17715 Meeting House Road, Sandy Spring  
[HPC Case # 28/11-12A]  
Sandy Spring Historic District

**MONTGOMERY COUNTY HISTORIC PRESERVATION COMMISSION**  
**STAFF REPORT**

<b>Address:</b>	17715 Meetinghouse Road, Sandy Spring	<b>Meeting Date:</b>	1/25/2012
<b>Resource:</b>	Outstanding Resource Sandy Spring Historic District	<b>Report Date:</b>	1/18/2012
<b>Applicant:</b>	Sandy Spring Monthly Meeting (Miche Booz, Architect)	<b>Public Notice:</b>	1/11/2012
<b>Review:</b>	HAWP	<b>Tax Credit:</b>	Partial
<b>Case Number:</b>	28/11-12A	<b>Staff:</b>	Josh Silver
<b>PROPOSAL:</b>	Relocation of and alterations to schoolhouse and alterations to Lyceum

3 TYPICAL GUARD & HAND RAIL DETAIL  
A5 Scale: 1/2" = 1'-0"

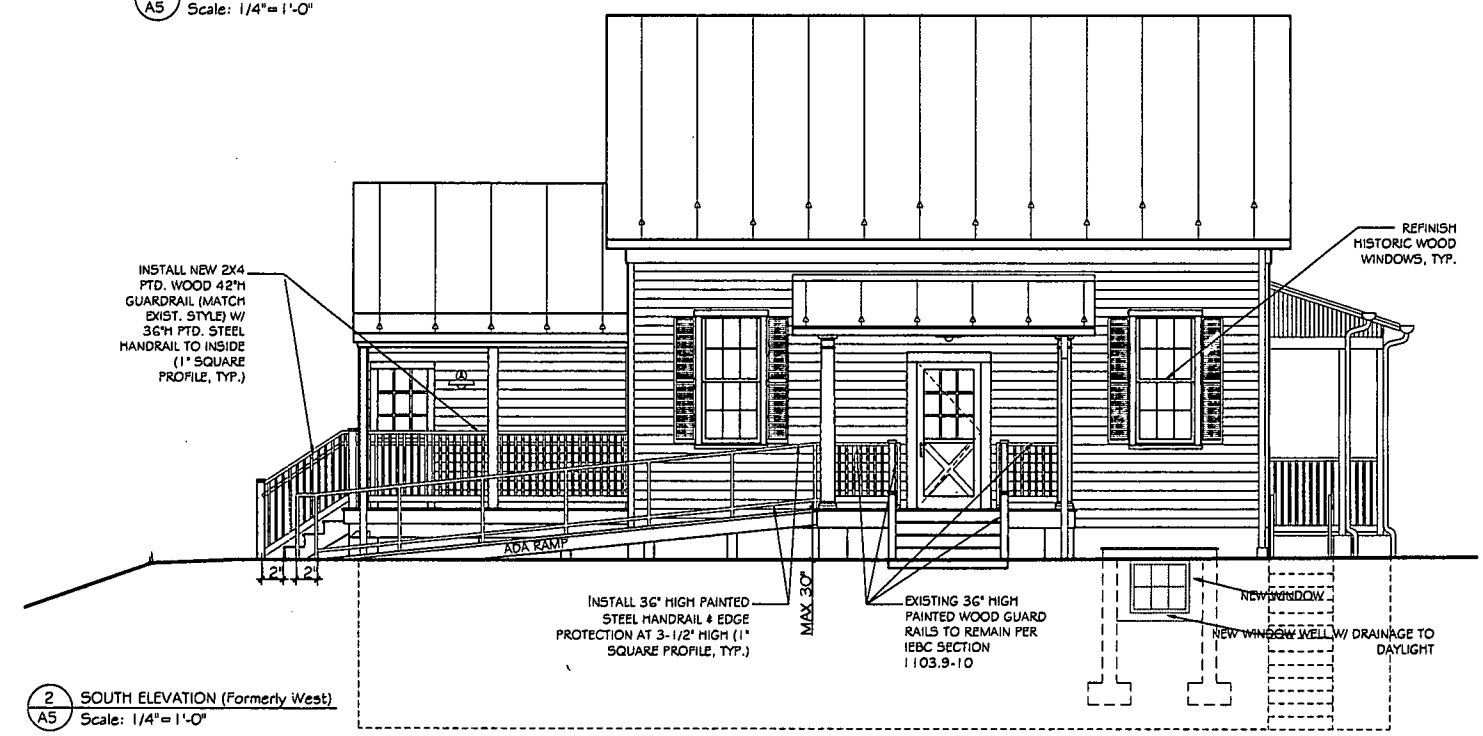
1. The guardrail details for the schoolhouse building should only extend 12 inches beyond the last stair riser. This specification was recommended for all stair units for consistency.
2. Consistent with the staff recommendation the HPC advised the applicant to rehabilitate where practicable the existing wooden siding that is currently underneath asbestos siding on the schoolhouse building. Where original wooden siding is beyond repair it must be replaced in-kind.

4 MR. KIRWAN: I have one. On circle 23 in the  
5 staff report, there is, for the schoolhouse relocation,  
6 there is a typical wood guardrail detail which is showing  
7 what I believe to be an older code requirement where the  
8 rail has to extend one tread plus 12 inches beyond the last  
9 riser.

10 And I believe the current code requirement only  
11 requires 12 inches beyond the last riser. And it seems to  
12 be consistent with other things in your drawing. And I  
13 think it would actually be, that old code detail looks very  
14 funky on stairs.

The applicants HAWP application submission responds directly to the recommendations provided by the HPC at the 2<sup>nd</sup> Preliminary Consultation hearing. The guardrail detail has been revised and the applicant is proposing to rehabilitate the existing wooden siding underneath the asbestos siding on the schoolhouse and in-kind replacement where repair is not practicable.
